Re: Miscellaneous Revisions to previously approved COA -63 MLK Blvd., # 2-0016 -17-006

We are requesting approval of minor revisions for New Construction, 63 Martin Luther King Jr. Boulevard. We feel the revisions are an improvement to the overall aesthetic and minor in overall scope. Both Part 1 and Part 2 review items are modified slightly. As per the previous approval, the building is within the boundaries of the National Historic Landmark District/Savannah Historic Overlay District. The overall footprint of the project does not change. The project will have the same +/- 29,992 square feet and is within a 5-story height zone. The total height of the main body of the building is +/-76'-0 + front parapet. The building will be in a contemporary Art Deco style. The building is at the west axis of Broughton at MLK and is unique in its site location. This project has been continued from 2017 and falls under the requirements of the previous Ordinance. As you are aware, the project received the Part 1 approval on October 9, 2019, and Part 2 approval on May 13, 2020. The project is currently in the site permit process and a site demolition permit has been approved by the city in fall of

<sup>2</sup> PTAC GRILL PLAN DETAIL A5.3 1" = 1'-O"

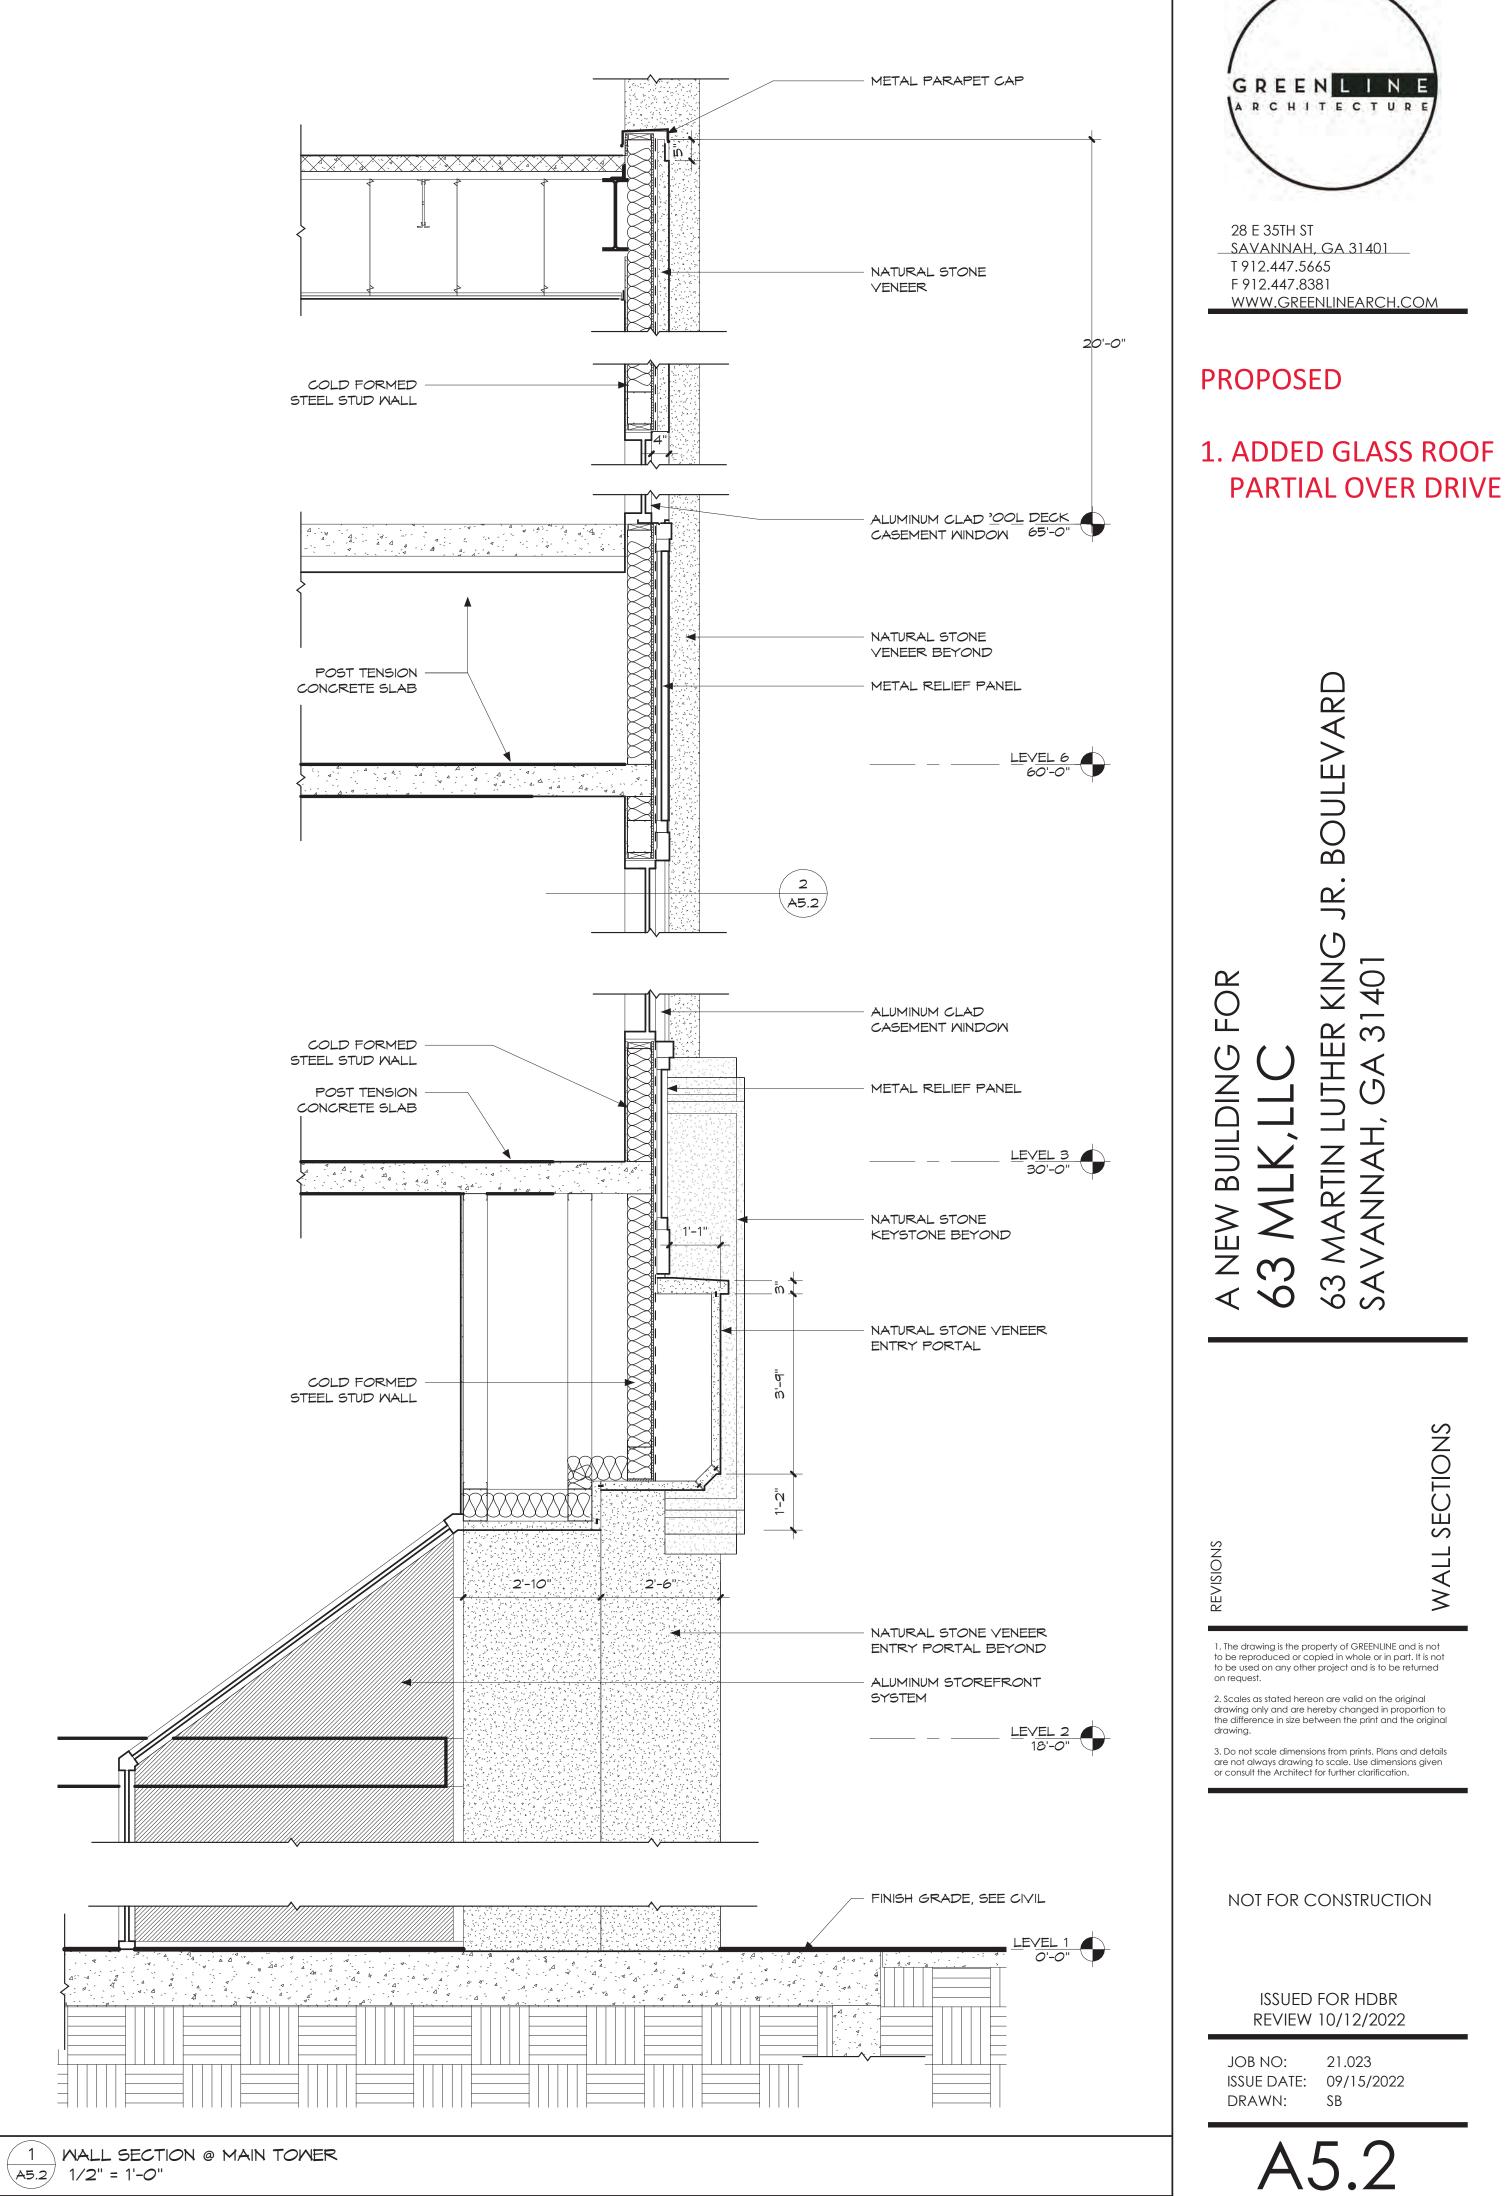
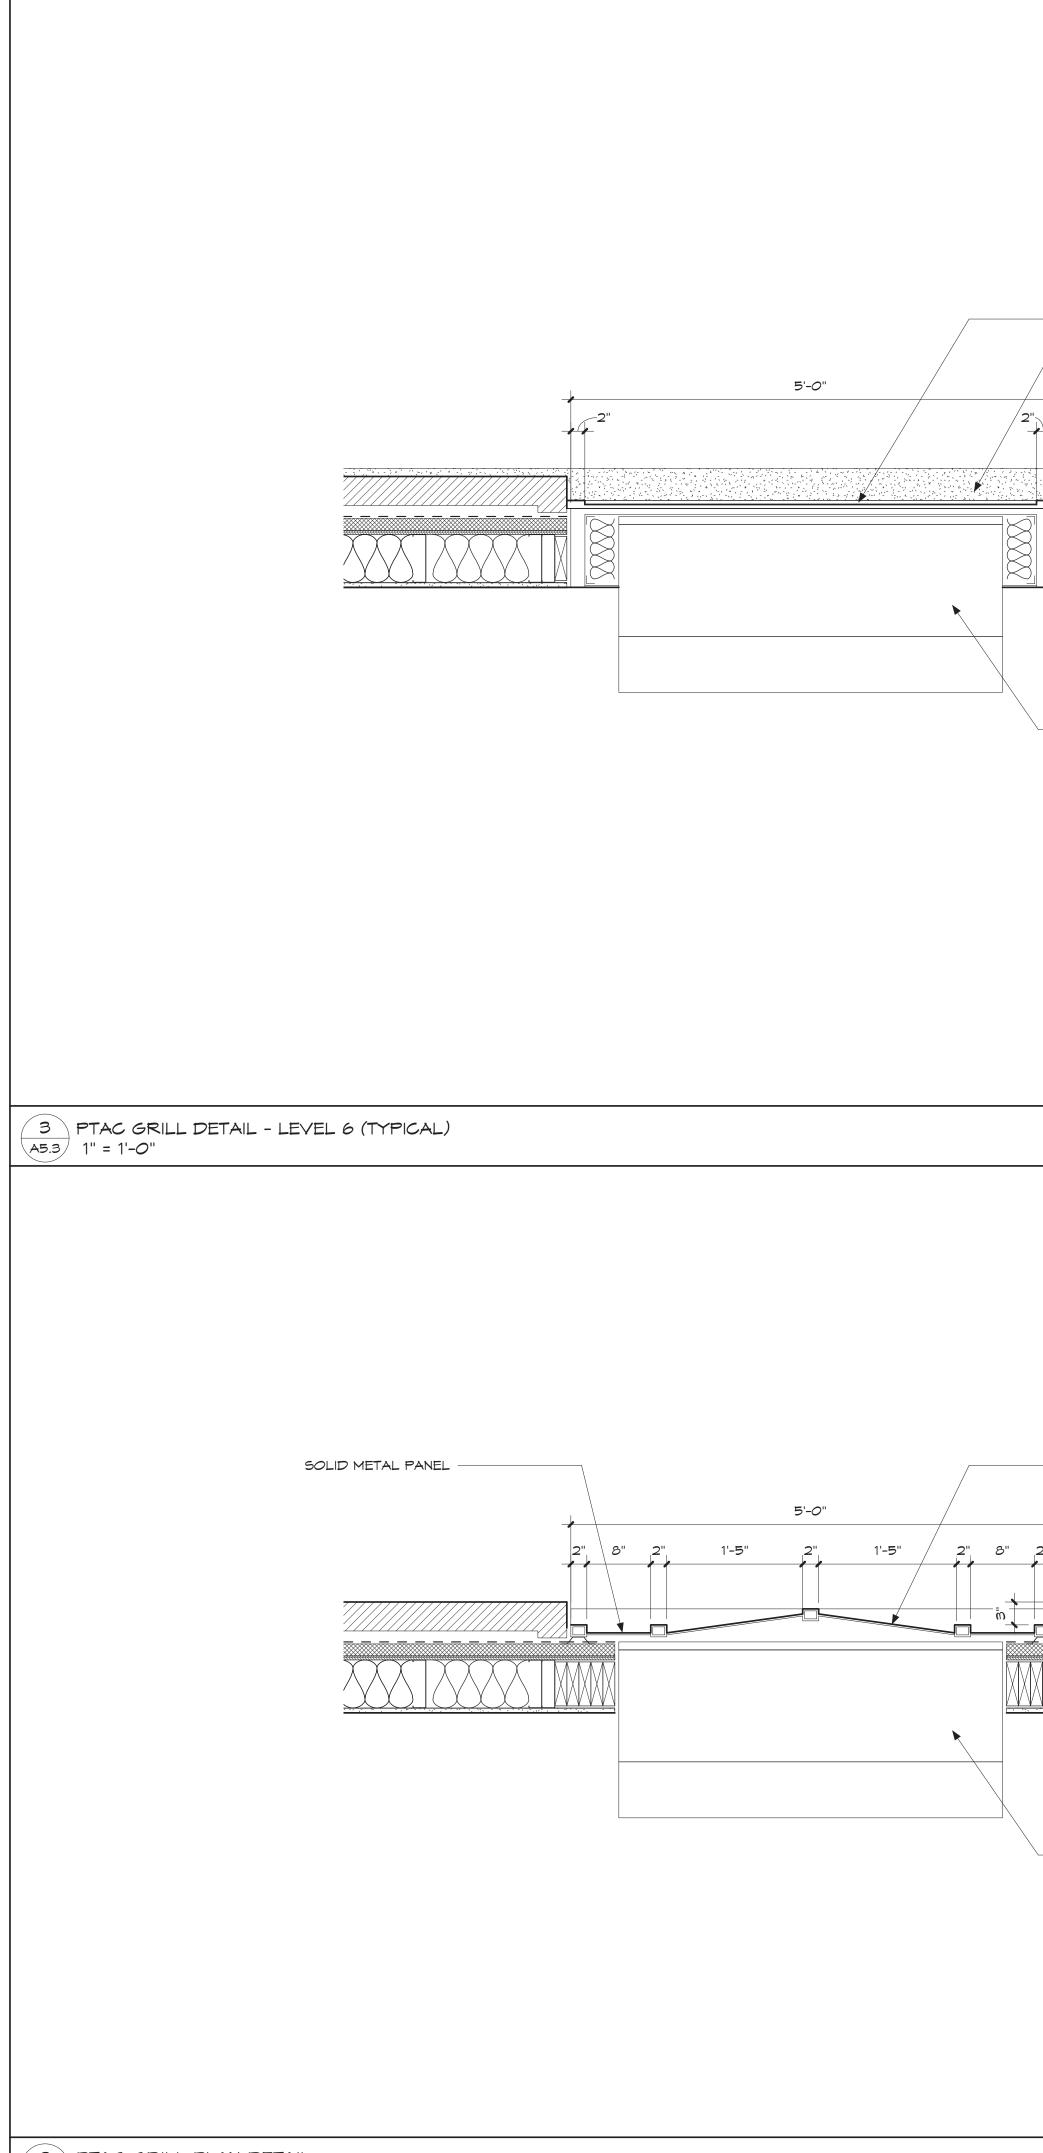
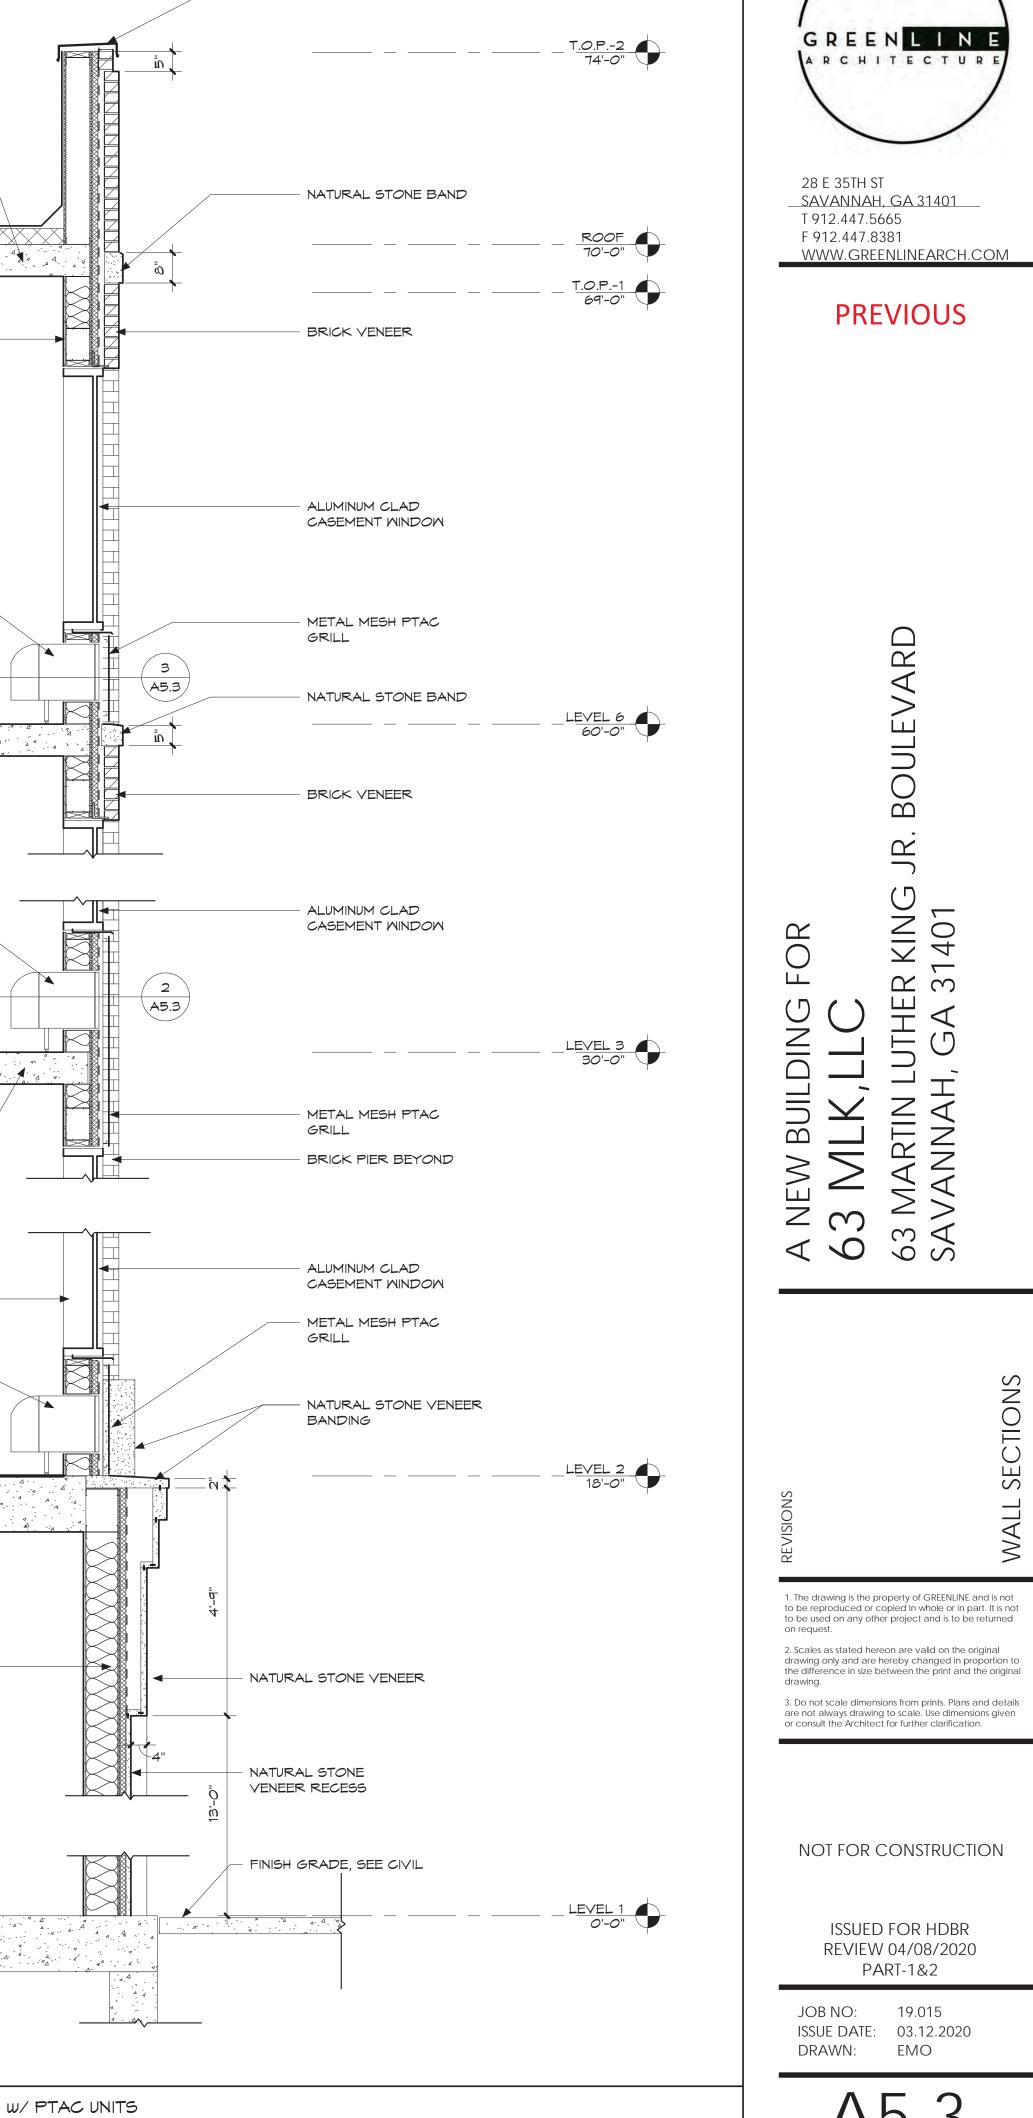
- 7.) We have removed all metal mesh/screening for the eliminated PTAC units.
- 8.) We would like to revise the natural stone finish to a similar product/system. The overall appearance and quality of the stone is the same. It is my understanding the revised product has been approved by the Board for other similar projects within the district and meets the intent of the ordinance. Please see finishes and literature on revised product.
